## General information

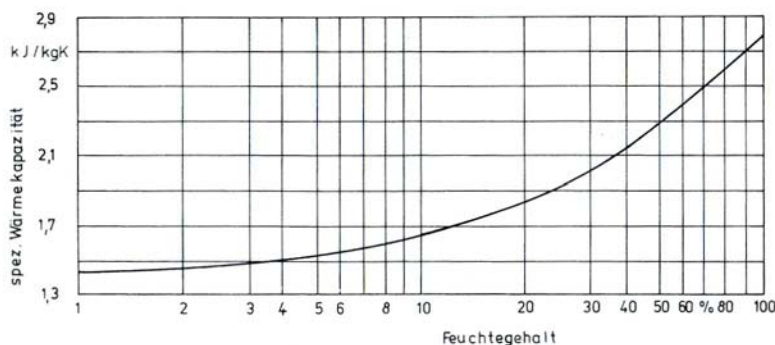
2-8 In Table 4-48 the mechanical properties of the steel materials are listed for the 1:3 test model and for the original cask. The values for the test model are actual values at room temperature as given in the material certificates of the manufacturing documentation. The values for the same steel materials can be different because for different parts of the model other feed material was used.

There is a writing error in Table 4-48 in the last column. The values listed for the ultimate strength  $R_m$  are not for 100 °C but for room temperature because only these values are specified in the standards, so the column header should read  $R_m$  at RT.

Taking this into regard there is no discrepancy to the values given in Tables 4-5, 4-8 and 4-11.

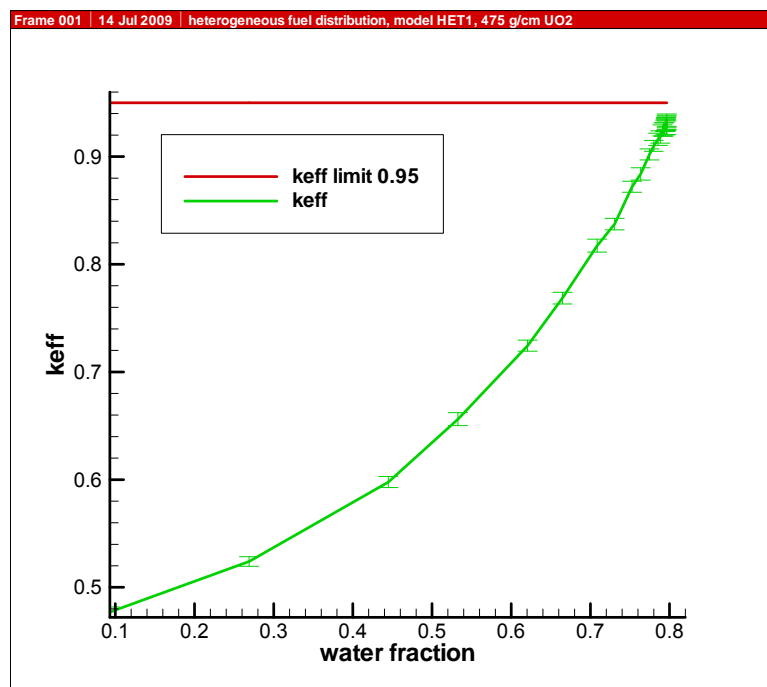
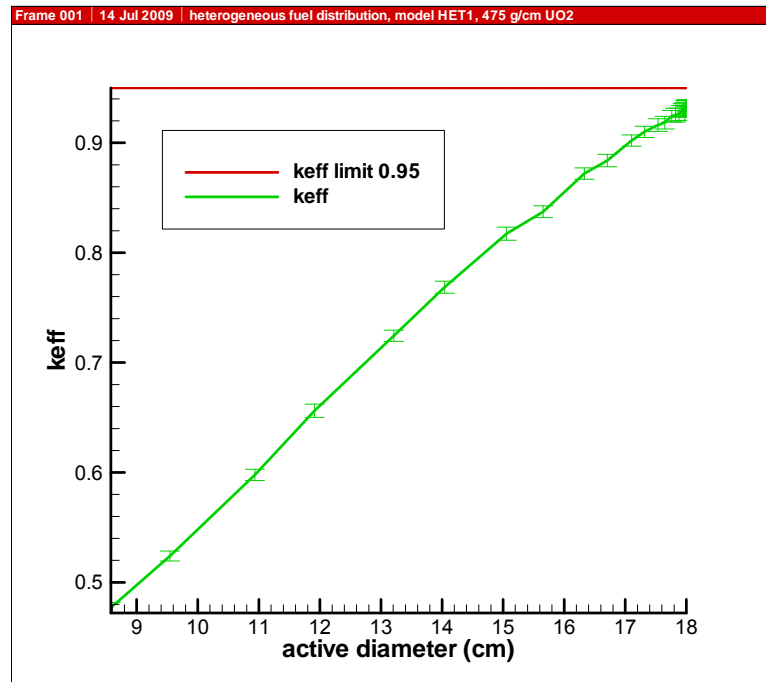
- 5-2 The methodology used for the proof for content 1.2 is based on the methodology used for the proof for content 1.1 with an additional "layer" of variational calculations.

For the most reactive case (26.2983 g/cm fissile material, water fraction 0.7966) the individual calculation is documented below in Table 1, Figure 1 and Figure 2.

So the fissile material distribution is varied between 5.4156 g/cm and 61.3038 g/cm active length and for each of these distributions the water fraction is varied from 0.0931 – which is for model HET1 always the most compact arrangement of the fuel rods in the smallest possible active diameter – up to the maximum possible water fraction which is reached when the array of fuel rods is fully expanded within the bounding 18 cm diameter.

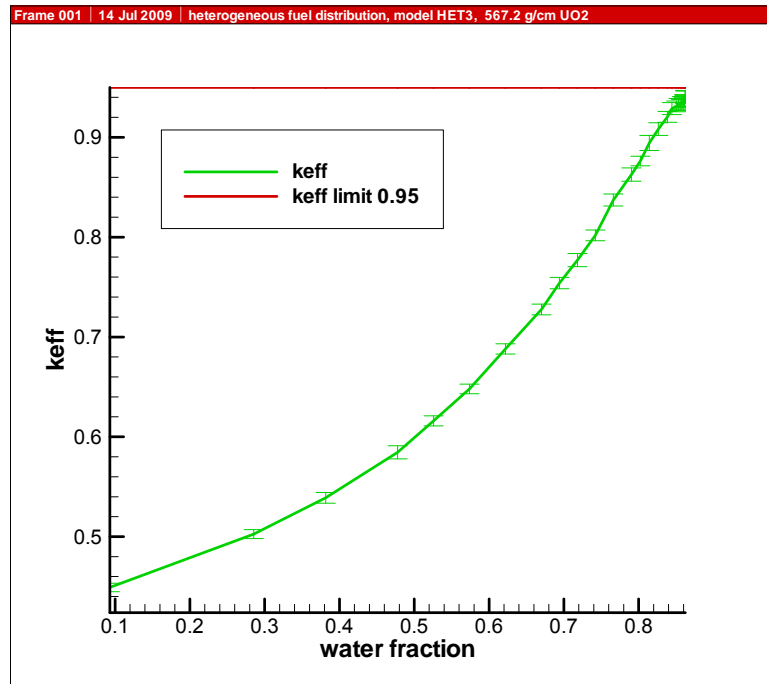
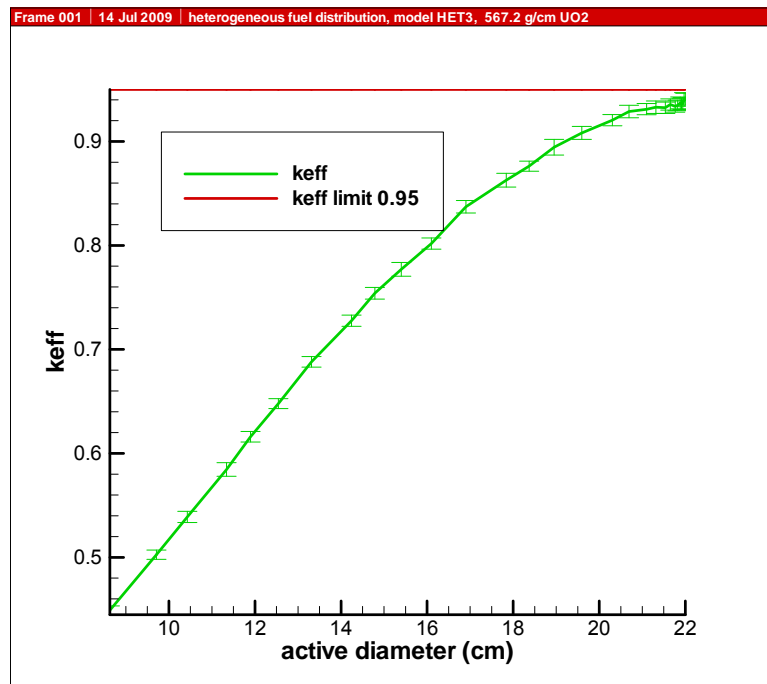
- 5-3 The methodology used for the proof for content 1.3 is based on the methodology used for the proof for content 1.1 with an additional "layer" of variational calculations (see also answer to question 5-2).

For the most reactive case (fissile height 52 cm, 26.5464 g/cm fissile material, water fraction 0.8624) the individual calculation is documented below in Table 2, Figure 3 and Figure 4.

So the fissile material distribution is varied between 13.6198 g/cm (for a fissile height of 100 cm) and 46.3197 g/cm active length (for a fissile height of 30 cm) and for each of these distributions the water fraction is varied from 0.0931 – which is for model HET3 always the most compact arrangement of the fuel rods in the smallest possible active diameter – up to the maximum possible water fraction which is reached when the array of fuel rods is fully expanded within the bounding 22 cm diameter of the cavity.

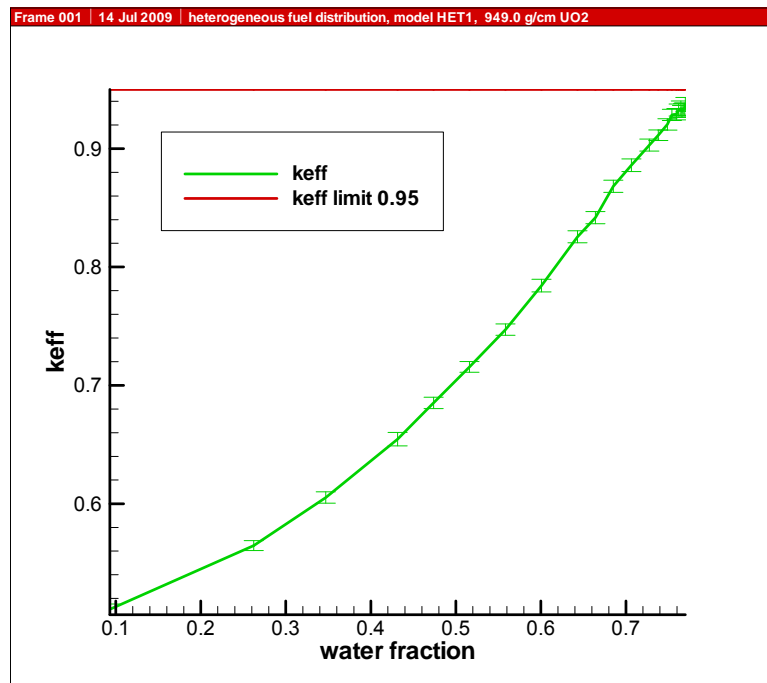
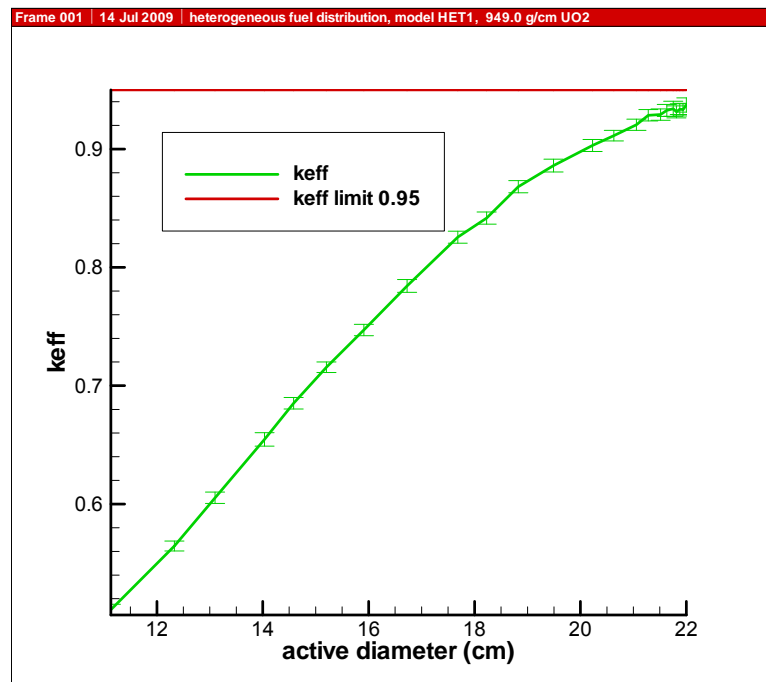
- 5-4 Please read fissile material radius as title of the second column of Table 8-9
- 5-5 Please see the details explained in answer to question 5-3.
- 5-6 The methodology used for the proof for content 1.4 in Section 8.6.1.4 is the same as used for content 1.2 (please see also the answer to question 5-2), however for content 1.4 the bounding diameter is the cavity diameter and for content 1.2 the bounding diameter is the centering frame tube with 18 cm diameter. Here like for content 1.2 the proof is based on the methodology used for the proof for content 1.1 with an additional "layer" of variational calculations.

For the most reactive case (28.1236 g/cm fissile material, water fraction 0.76996) the individual calculation is documented below in Table 3, Figure 5 and Figure 6.

So the fissile material distribution is varied between 13.9308 g/cm and 52.9901 g/cm active length and for each of these distributions the water fraction is varied from 0.0931 – which is for model HET1 always the most compact arrangement of the fuel rods in the smallest possible active diameter – up to the maximum possible water fraction which is reached when the array of fuel rods is fully expanded within the bounding 22 cm diameter.

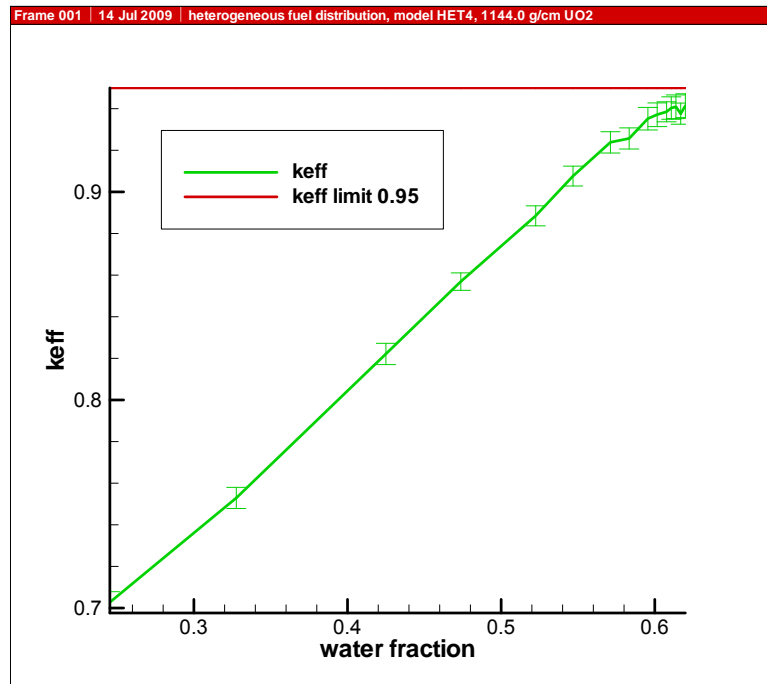
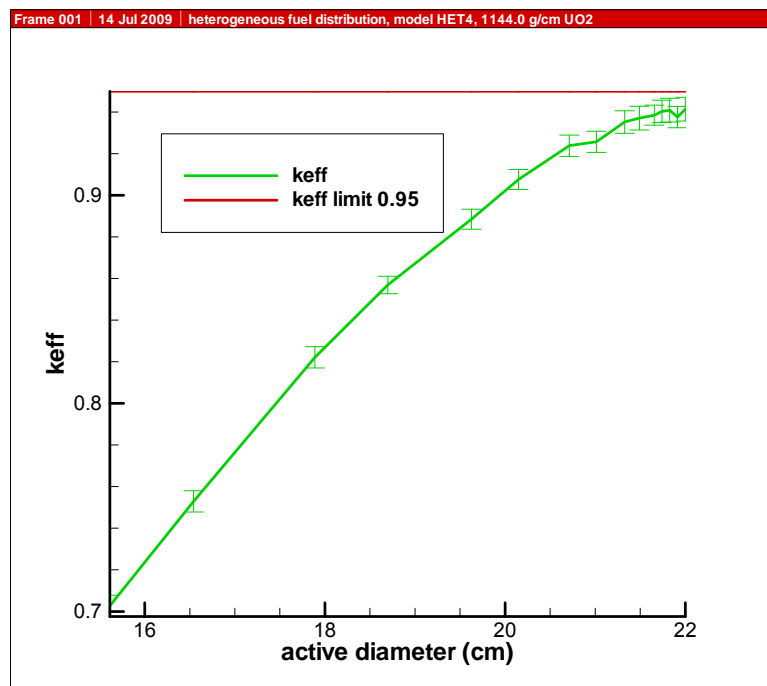
5-7 The methodology used for the proof for content 1.5 in Section 8.6.1.5 is the same as used for content 1.2, 1.3 and 1.4 (please see also the answer to question for these contents). For content 1.5 the bounding diameter is the cavity diameter as for content 1.4. Here like for content 1.2, 1.3 and 1.4 the proof is based on the methodology used for the proof for content 1.1 with an additional "layer" of variational calculations.

For the most reactive case (69.7 g/cm fissile material, water fraction 0.6199) the individual calculation is documented below in Table 4, Figure 7 and Figure 8.

So the fissile material distribution is varied between 36.6 g/cm and 121.9 g/cm active length and for each of these distributions the water fraction is varied from the smallest possible value – which depends for model HET4 on the specific configuration for the smallest possible active diameter – up to the maximum
